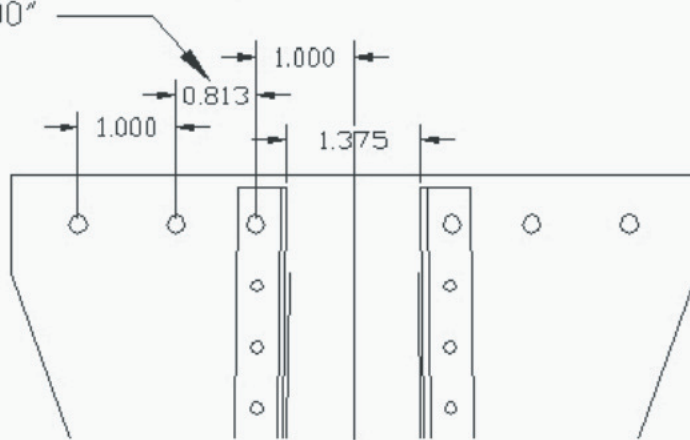
1. Changed hole spacing on the Strut plate to clear wing attach fitting bolts.
was 1.00"

2. Changed brake to .188" plate.

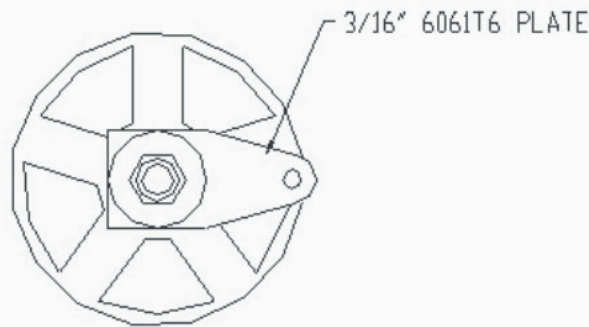
1. Changed the .5" square tube to .049" wall thickness because of better availability.
